India's comments/Suggestions on Low Powered Vehicle Cycle designed by Heinz Steven

**Z A Mujawar
WLTP/DHC meeting on 29th March
2012 at Ispra, Italy.**

Steven Proposal for LPVC for C1 LOW Phase Vs WLTC v4 LOW Phase

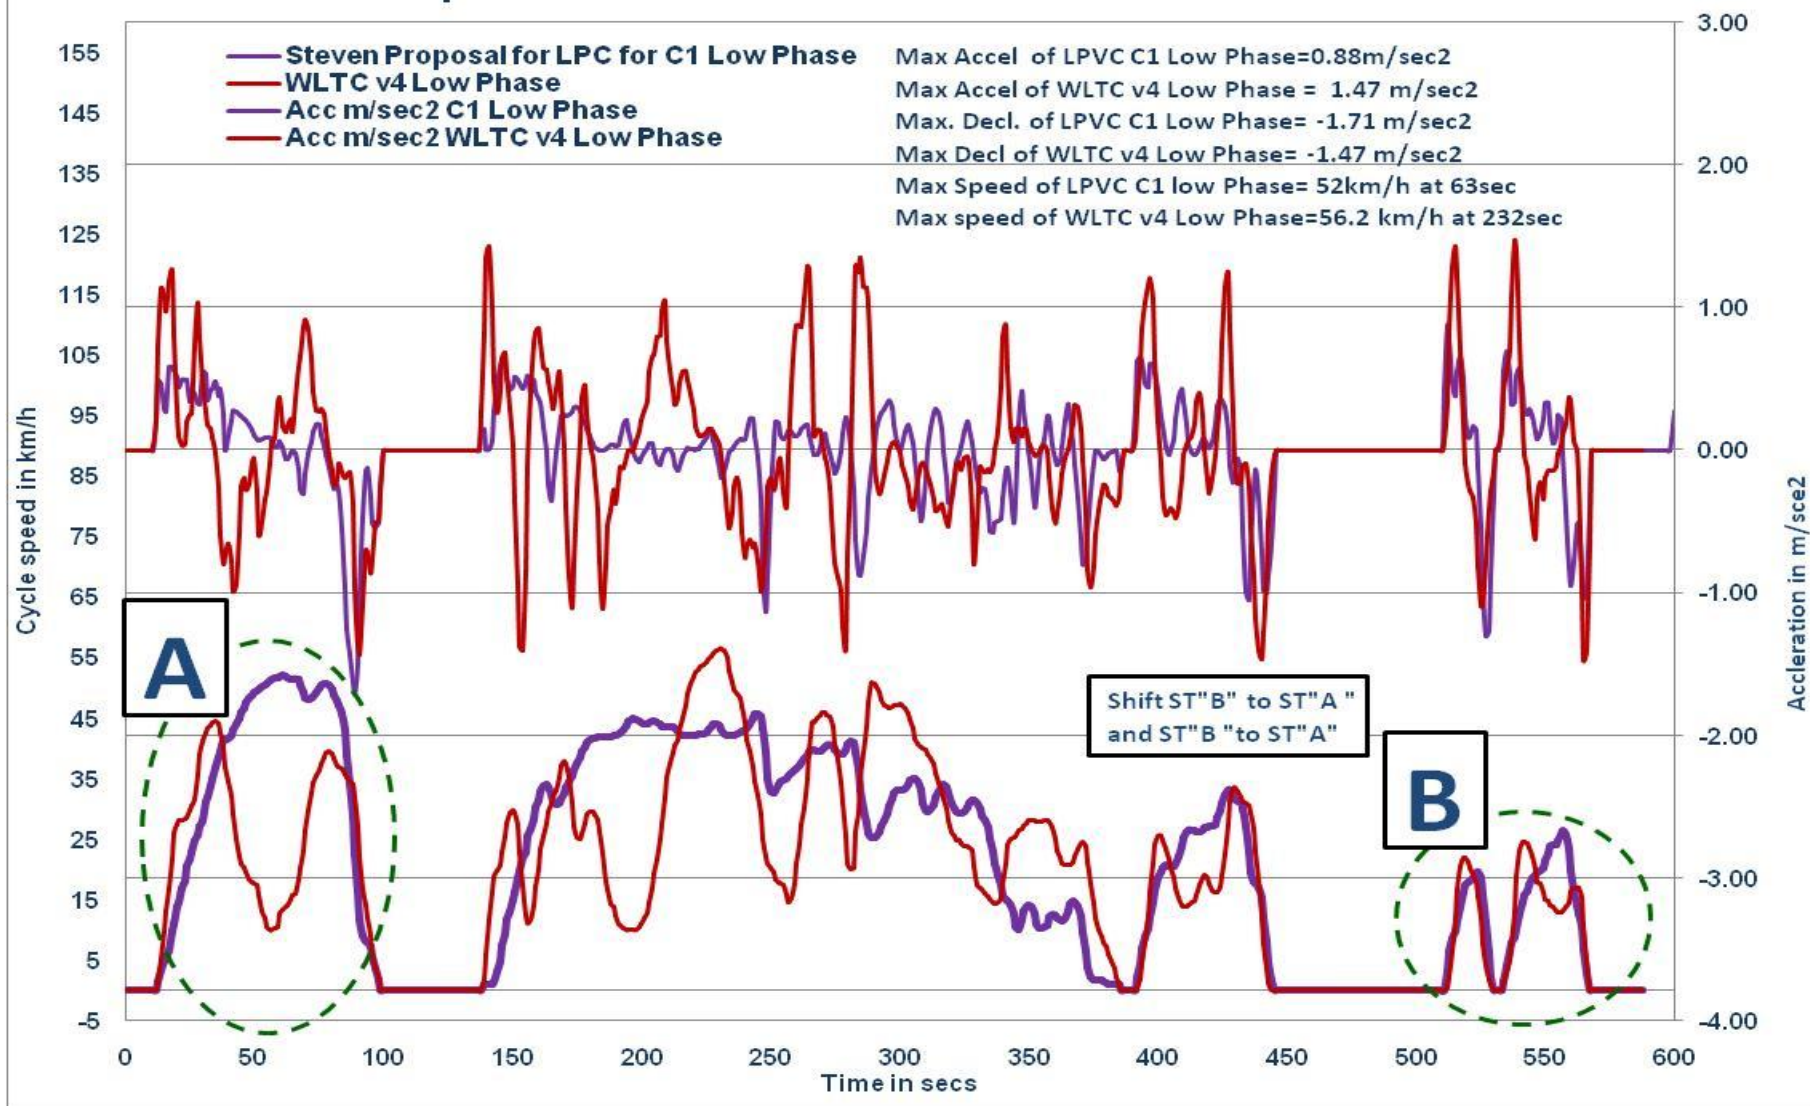
- The Low Powered Vehicle Cycle Class 1 proposed by Mr. Heinz Steven needs to be modified for better driveability on chassis dynamometer and moderated in the deceleration portions to avoid excessively aggressive braking.
- **Modification 1** is shown in Slide No.7 in which the Short Trip “A” is interchanged with Short Trip “B” marked in Slide No.6.
- Modification 1 in Slide No.7 also show the idling portions interchanged at the later part of the Cycle.
- Also the maximum speed of the last Short Trip needs to be reduced from 52 km/h to 45 km/h. This would allow the vehicles with max. speed of 55 to 60 km/h to go through the Cycle without opening full throttle.

The Short Trip "A" is interchanged with Short Trip "B"

Proposed Modification 2 of Low Phase of LPVC of Class 1

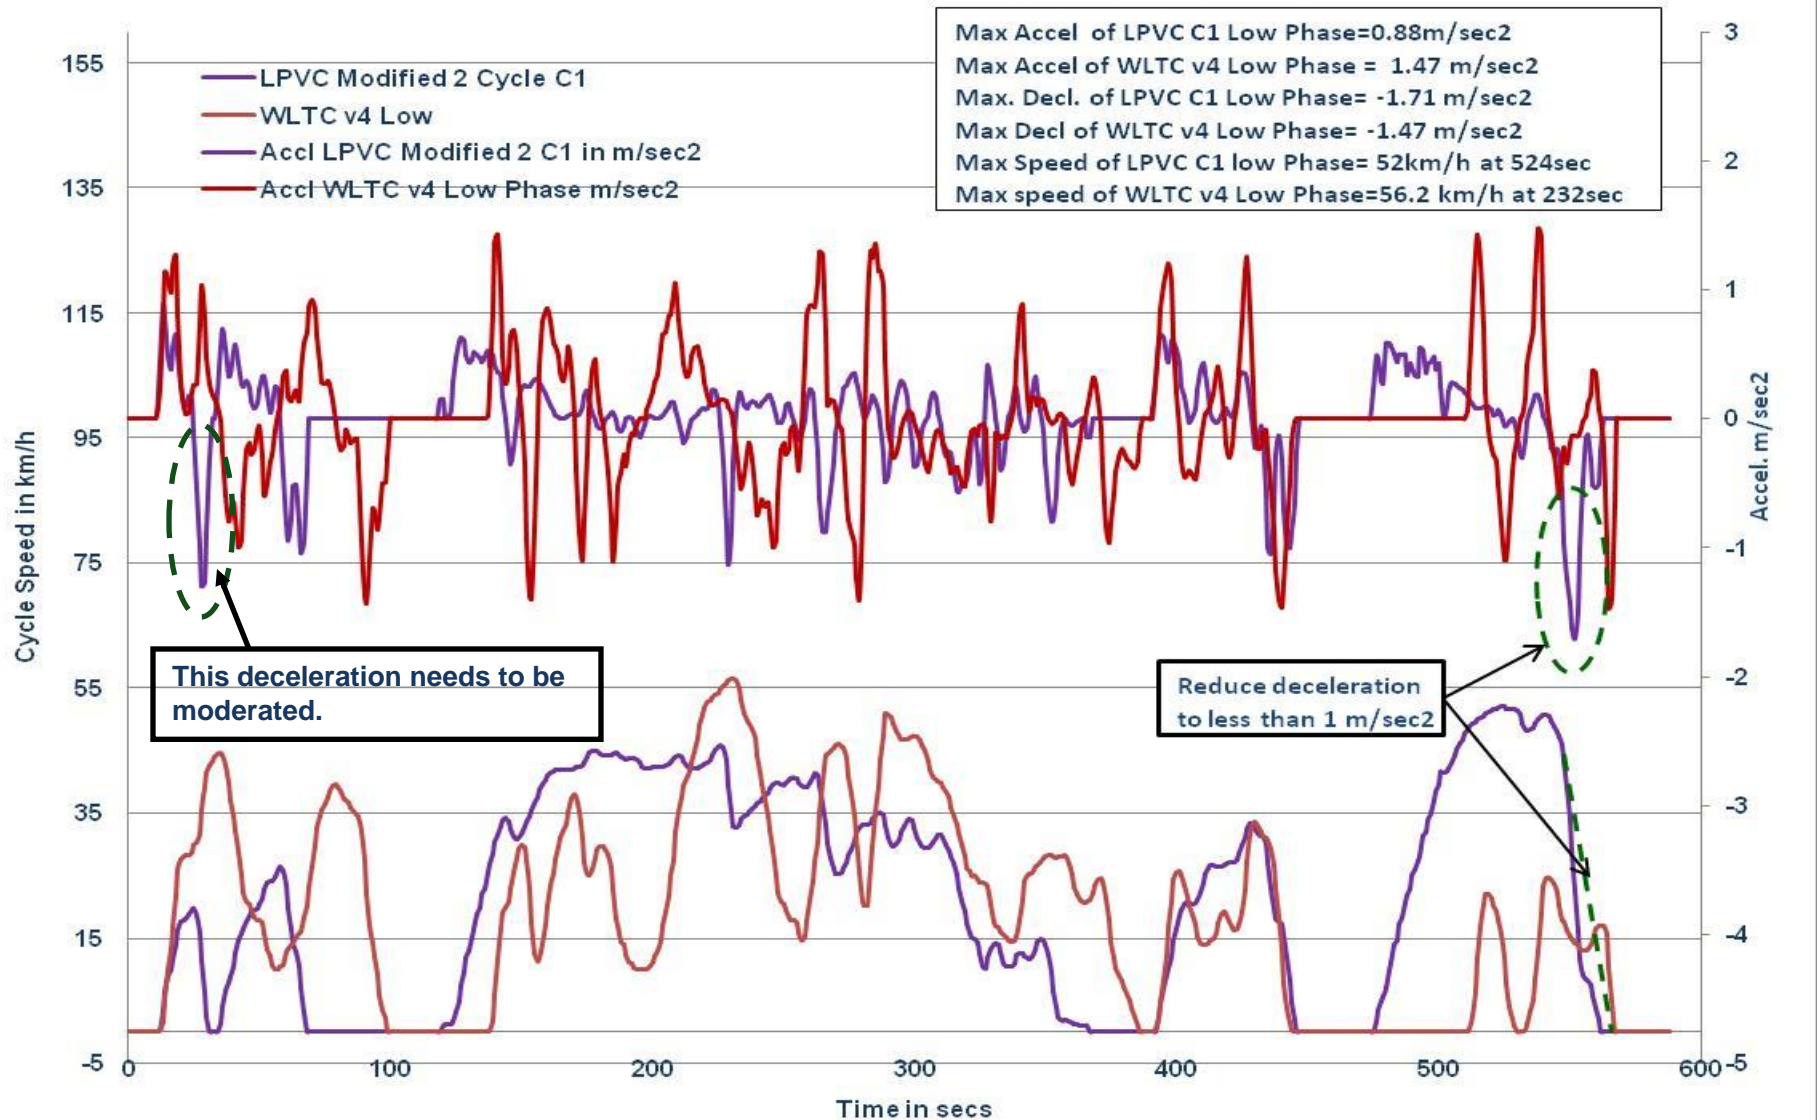
- **Modification 2** in Slide No.8 shows the need for moderating the deceleration in the last Short Trip to avoid excessively aggressive braking.
- For Class 2 Low, Middle and High phases the deceleration needs to be reduce to lower than WLTC Ver 4. See Slide No. 10, 11 and 12.
- The drive cycle for Class 2 also needs to have gradual speed increase. This can be achieved by interchanging the first & the last short trips in low speed phase as shown in Slide No. 10.
- **Modification 3** Our earlier tests indicate that the vehicle does not get fully warmed up after middle speed phase. Hence, in order to get more realistic conditions, the third phase needs to be added for all class-1 & class-2 vehicles. This can be achieved by repeating the phases. Further inputs can be given after conducting LPVC Validation 1.

Moderate the deceleration in the last Short Trip reduce excessive braking.

Steven Proposal for LPVC for C2 Low Phase Vs WLTC v4 Low Phase

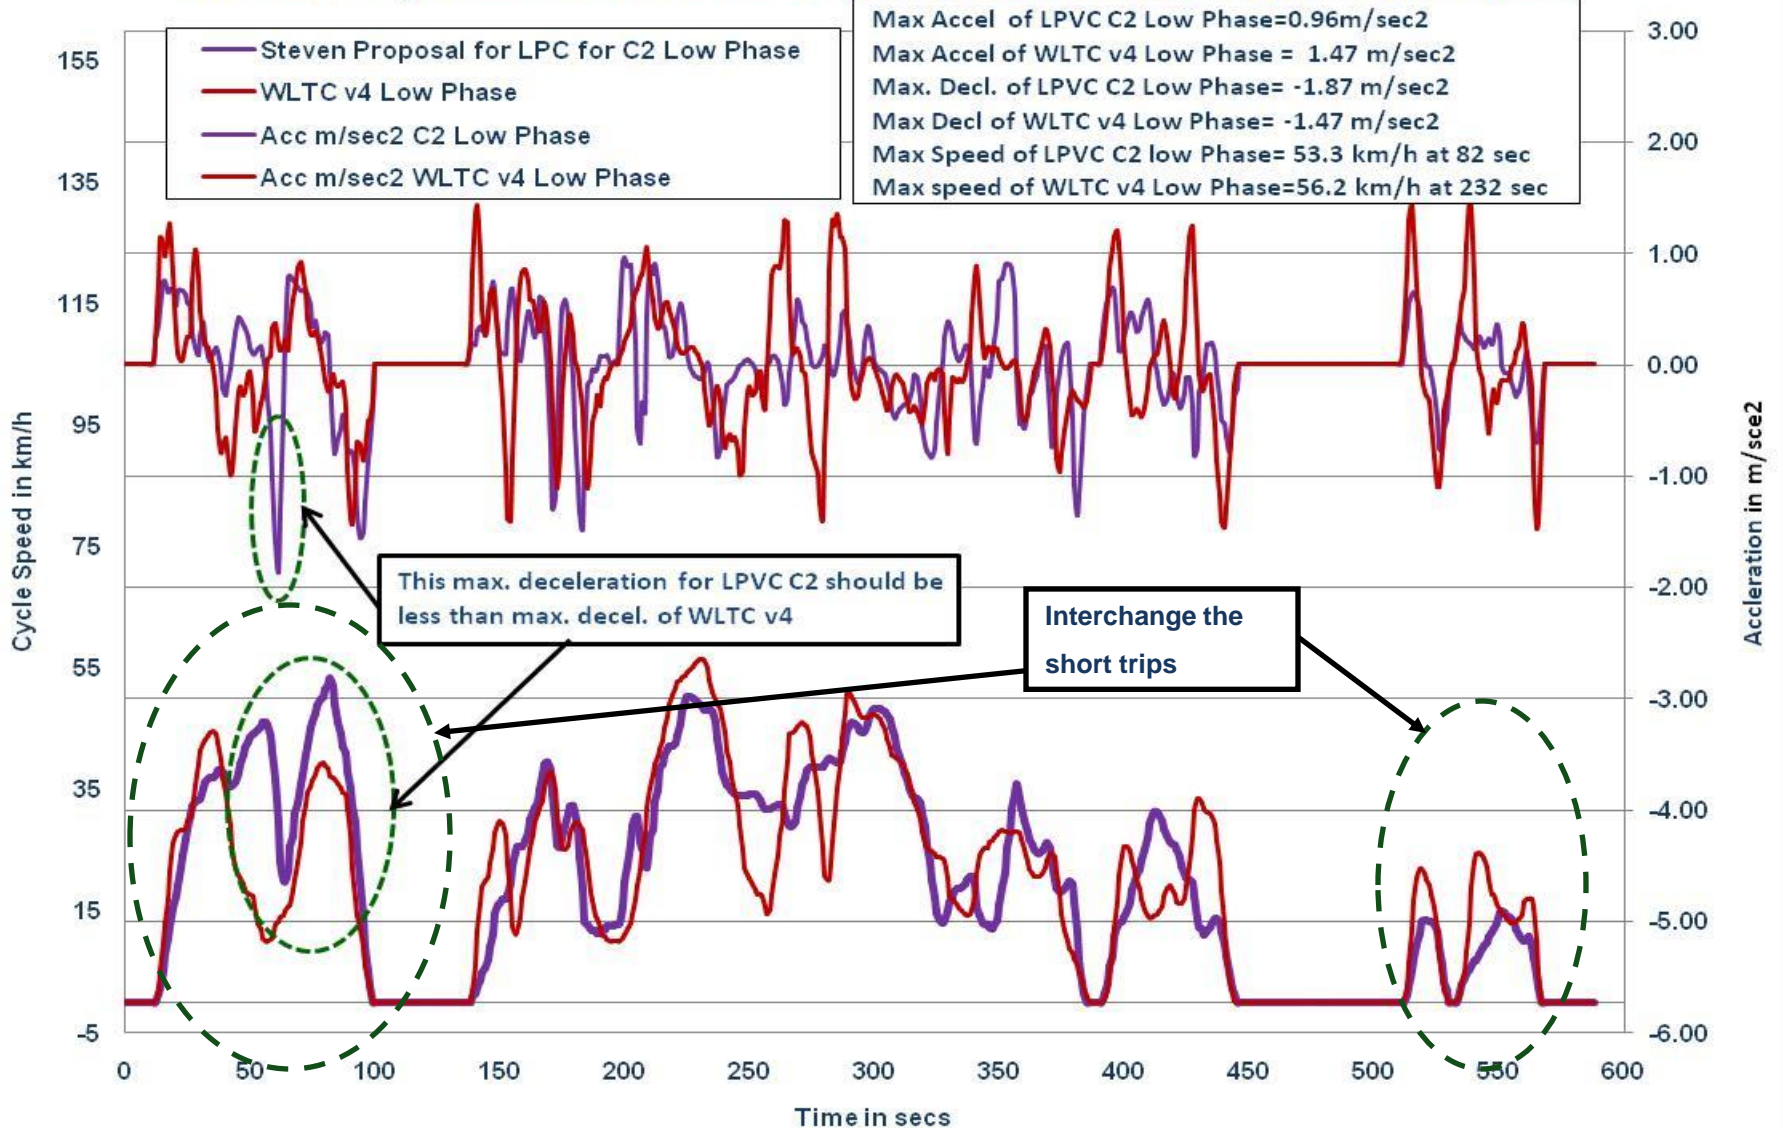
**Reduce the max deceleration for LPVC to lower than WLTC Ver 4.
The first & the last short trip needs to be interchanged.**

Steven Proposal for LPVC for C2 Middle Phase Vs WLTC v4 Middle Phase

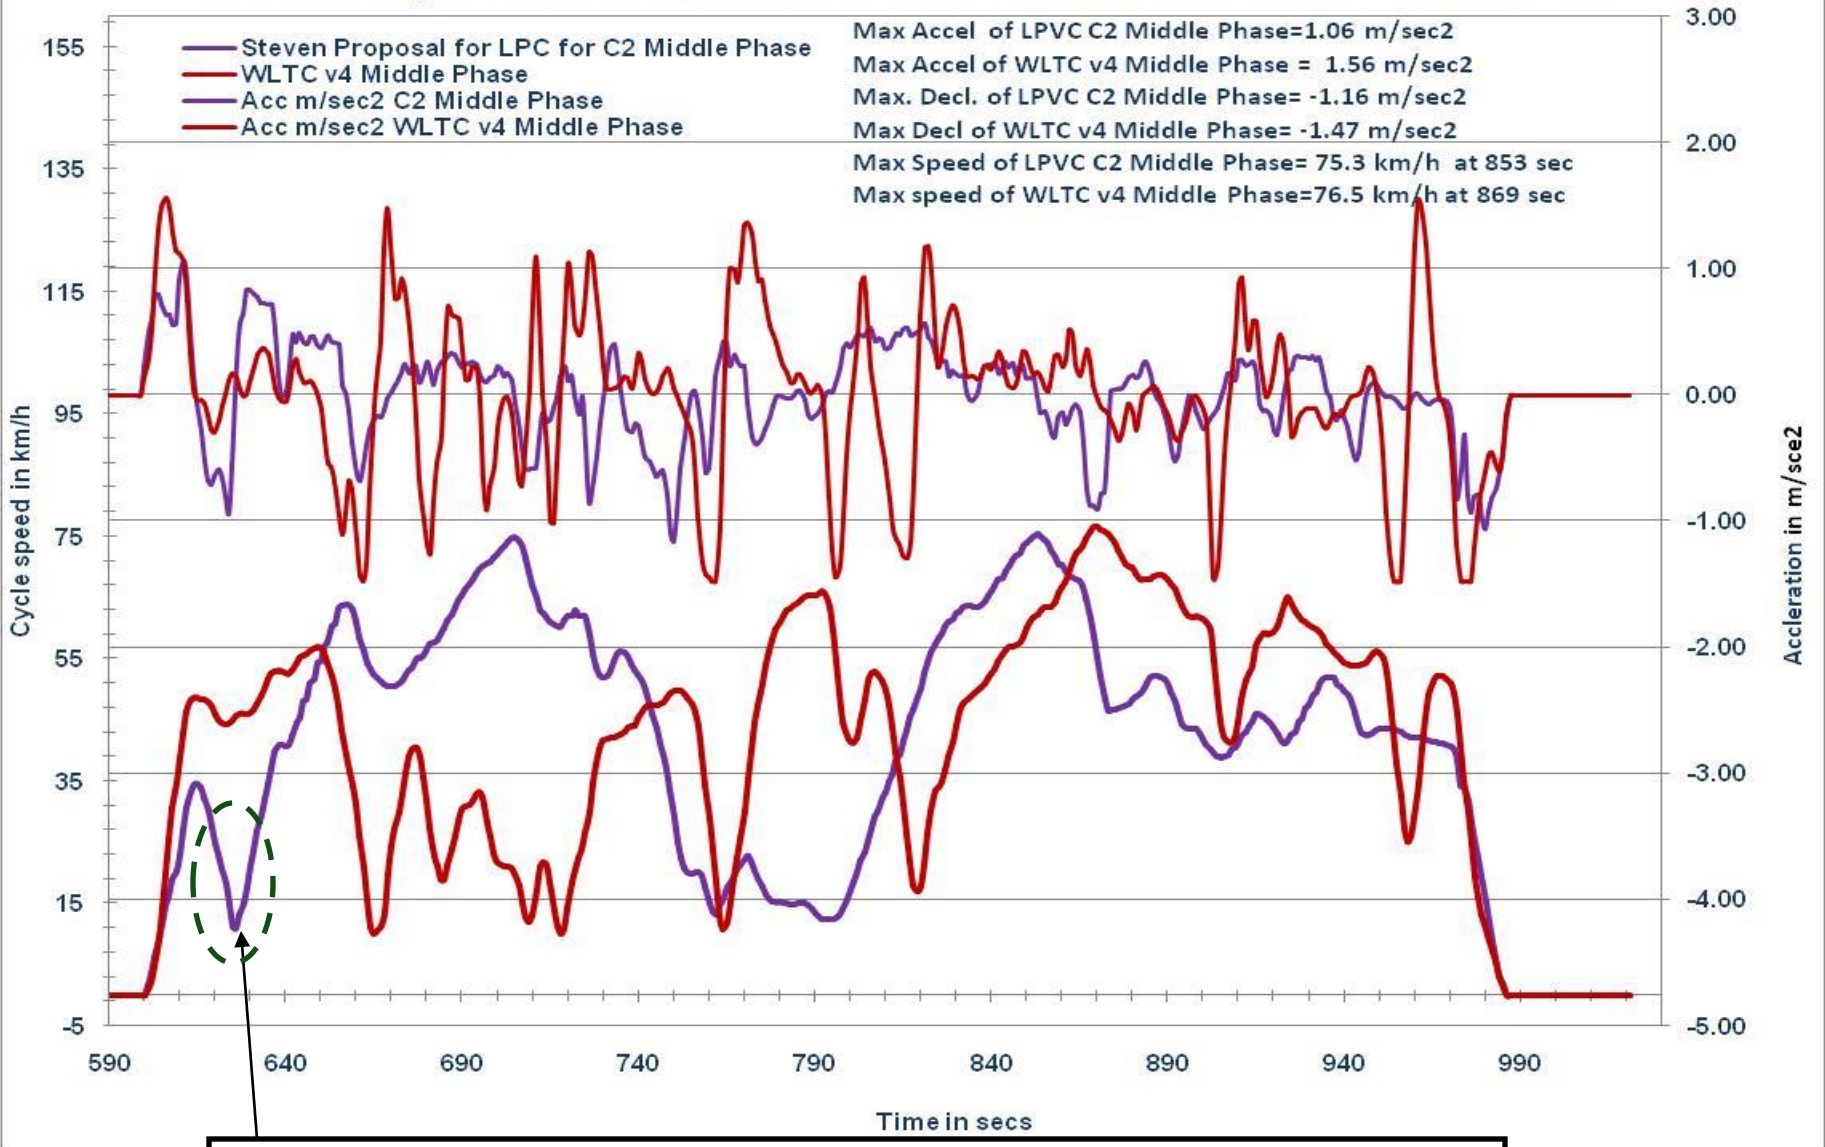
**This deceleration & acceleration needs to be moderated.
A steady speed step also needs to be provided.**

Steven Proposal for LPVC for C2 High Phase Vs WLTC v4 High Phase

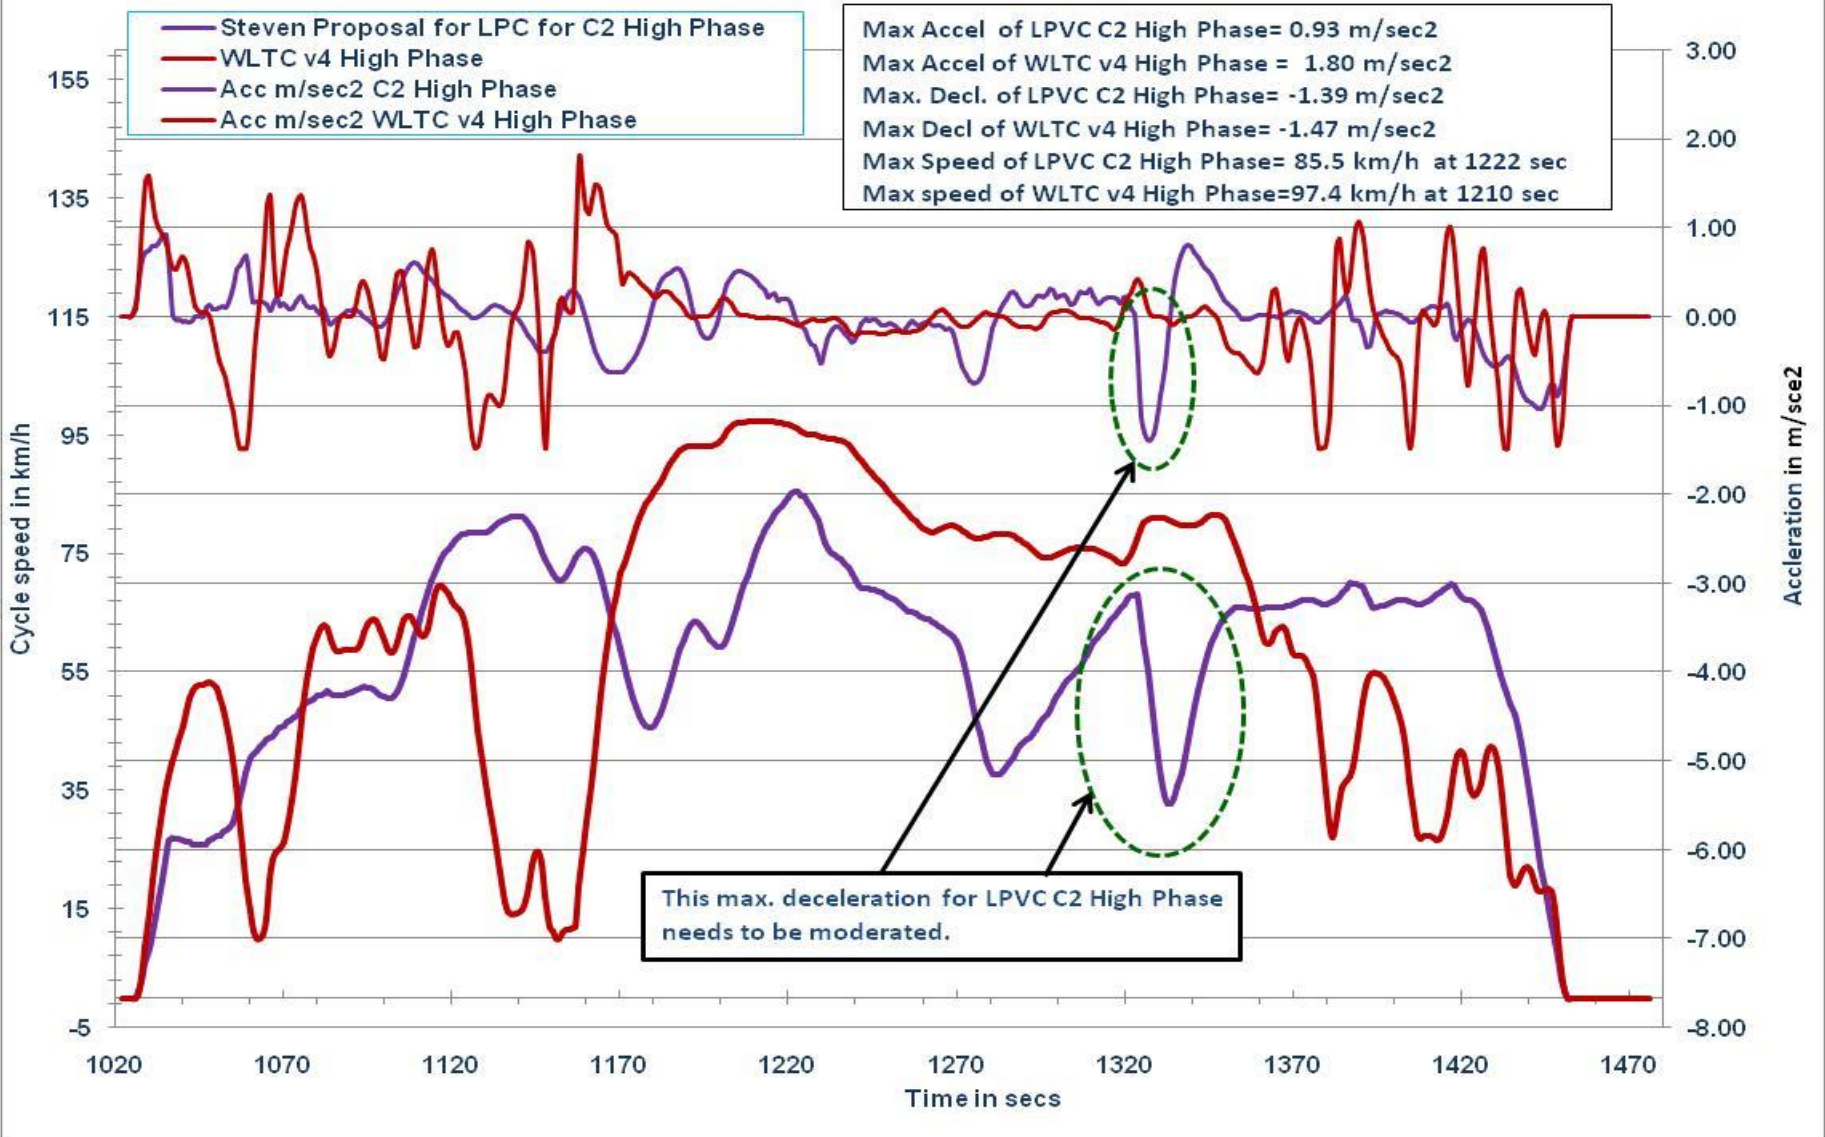
Reduce the max deceleration for LPVC Class 2 High phase.
